July 20, 2018

Urgent: Important Safety Update
Medical Device Correction for the AFX[®] Endovascular AAA System

Please note this notice provides updated information and revisions to the Instructions for Use (IFU) to enhance patient safety. No product return is required.

Figure 1: AFX Implant Design

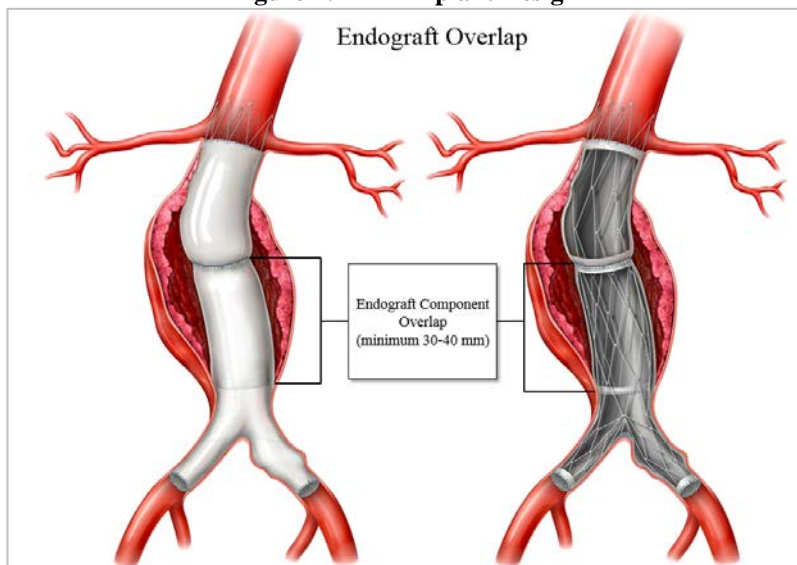
Endologix recognizes there may be a clinical need to either perform an intervention through a previously implanted AFX device (e.g., to gain vascular access for a coronary procedure), or a re-intervention on such a device (e.g., for treatment of a Type III endoleak). As illustrated in **Figure 1**, the AFX implant has a unique endoskeleton design where the ePTFE is only attached to the most proximal and distal stent apices of the implant. The ePTFE is not attached to the stent cage throughout its entire length.

Based on this unique design, Endologix has developed guidelines that should be considered in intervention/re-intervention situations to ensure that devices can be tracked through the previously implanted AFX device without damage. This includes step-by-step instructions on how to best navigate the endoskeleton design of the existing AFX device in order to obtain and confirm proper wire access. These guidelines are intended to help guide the physicians and do not take the place of physician judgement. Refer to Appendix 4 and Appendix 5 for an outline of the complete intervention and re-intervention guidelines, respectively.

13.1: General Use Information	<p>Due to its unique endoskeleton design and because the ePTFE is not attached to the stent cage throughout its entire length (Figure 1), the techniques described in the sections below should be employed during an intervention that may be traversing/crossing/transferring through the AFX Endovascular AAA System.</p> <p>CAUTION: <i>Systemic anticoagulation should be used during the intervention procedure based on hospital and physician preferred protocols. If Heparin is contraindicated, an alternative anticoagulant should be considered.</i></p> <p>CAUTION: <i>The ePTFE graft is not attached to the stent throughout its entire length and could give the appearance of a properly placed wire or accessory, when the wire may be inadvertently placed behind a stent strut.</i></p> <p>WARNING: <i>Excessive movement during catheter advancement may lead to cephalad movement of the existing AFX device(s), which may result in inadvertent visceral coverage.</i></p> <p>WARNING: <i>Excessive manipulation during catheter advancement may lead to damage of the existing AFX device, which may result in a Type IIIb endoleak.</i></p>

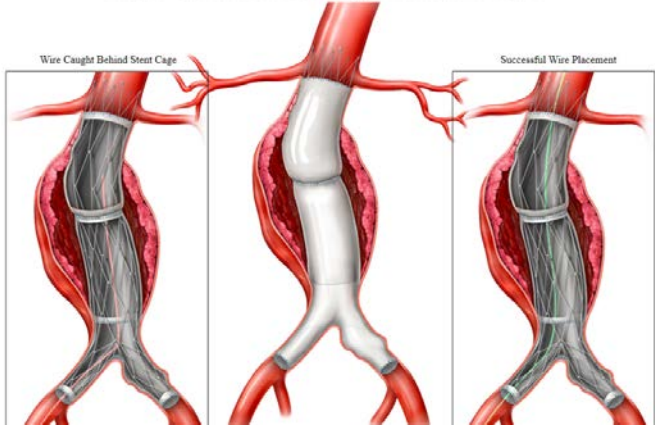
13.2: Pre-Procedure Planning	<p>As part of pre-procedure planning, verify that an appropriately-sized catheter or accessory device (e.g., balloons, flexible “J-tip” guidewires, pigtail catheters) have been selected to track through the previously implanted AFX Endovascular AAA System without damage. Determinants include:</p> <ol style="list-style-type: none"> 1. The number of modular AFX components currently implanted may impact the flow lumen and/or endoskeleton diameter and should be considered when planning an intervention that requires transferring through the existing AFX device. <p>NOTE: The information provided in the subsequent sections is intended to assist physicians in tracking through the existing AFX device. Follow the manufacturer’s instructions for use for additional pre-procedure planning.</p>

14.2: Imaging Guidelines and Post-Operative Follow Up	<p>Procedurally, fluoroscopic imaging in multiple planes should be used to verify that no accessory devices are placed behind a stent strut (Reference Figure 4). Imaging should also be used after device placement to ensure the existing AFX device has not been damaged and to ensure that the reason for the re-intervention has been addressed.</p> <p>Assuming no additional concerns have been identified, Endologix recommends, at a minimum, that high-resolution CT scan (contrast-enhanced and non-contrast) imaging follow-up to be performed at one month, six months, one year, and annually thereafter following any re-intervention. Alternative imaging modalities such as magnetic resonance imaging, plain X-Ray or duplex ultrasound may be used in patients with impaired renal function or intolerance to contrast media. Determination of imaging techniques should be based on the physician's clinical assessment of the patient and stent graft implant, including any adjunct procedures that may have been performed in conjunction with the endovascular stent graft procedure.</p>

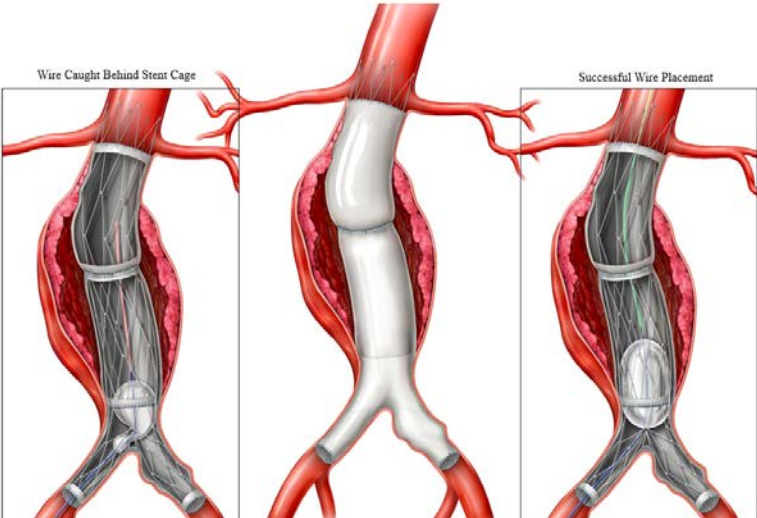
New IFU Section	Content
<p>13.3: Patient Preparation/ Arterial Access</p>	<ol style="list-style-type: none"> 1. Refer to institutional protocols relating to anesthesia, anticoagulation and monitoring of vital signs. 2. Position patient on imaging table allowing fluoroscopic visualization from the aortic arch to the femoral bifurcations. 3. Gain luminal access through the femoral arteries. 4. Establish adequate proximal and distal vascular control of the surgically exposed femoral artery, as needed. 5. Following the manufacturer’s instructions for use, advance a flexible “J-tip” guidewire, pigtail catheter, or acceptable equivalent, into the vasculature under fluoroscopy. <ul style="list-style-type: none"> • NOTE: Proper device choice may limit the likelihood of tracking behind a stent strut. Reference Figure 4. <p>Figure 4: Ensure Guidewire Is Not Caught Behind Stent Strut Ensure Guidewire is Not Caught Behind Stent Strut</p>  <p><i>*Note: Figure 4 corresponds to Figure 17 of the IFU</i></p> <p>CAUTION: <i>Tortuosity and angulation may impact the morphology of the endoskeleton within the vasculature. Use caution when tracking devices through the existing AFX device.</i></p> 6. Once the flexible “J-tip” guidewire or pigtail catheter reaches above the existing AFX device, slowly advance an occlusion balloon or PTA balloon over the wire and under fluoroscopy. Slowly inflate, per the manufacturer’s instructions, until the balloon has been fully shaped or formed. It is recommended to use a 12mm diameter PTA balloon or an occlusion balloon that is partially inflated to ensure devices are not behind a stent strut. <ul style="list-style-type: none"> • Advance and retract the balloon catheter up and down the entire length of the existing AFX device to ensure there is proper luminal wire access. <ul style="list-style-type: none"> ○ NOTE: Balloon kinking during inflation or enlargement of a section of the stent cage may be a signal of a potential wire placed behind a stent strut. Reference Figure 5.

New IFU Section	Content
	<p>Figure 5: Use of a Balloon to Confirm Correct Placement of Guidewire</p> <p>Use of a Balloon to Confirm Correct Placement of Guidewire</p>  <p><i>*Note: Figure 5 corresponds to Figure 18 of the IFU</i></p> <p>CAUTION: <i>Balloon inflation and advancement should be performed slowly so as not to damage or dislodge the existing AFX device.</i></p> <p>WARNING: <i>Overinflation of the balloon to ensure luminal access may create the false appearance of a wire placed behind a stent strut or may shift the main body cephalad.</i></p> <ol style="list-style-type: none"> 7. During inflation and while tracking through the aortic lumen, fluoroscopic imaging in multiple planes should be used to verify that no accessory devices are behind a stent strut. 8. After verifying correct wire placement fluoroscopically, the balloon should be removed and use of alternative techniques (e.g., intravascular ultrasound) may be helpful to confirm correct wire placement. 9. Should incorrect wire placement behind a stent strut be observed, remove wire and re-advance guidewire/pigtail catheter, as described above. 10. Repeat Steps 5-8 for contralateral access, if appropriate.
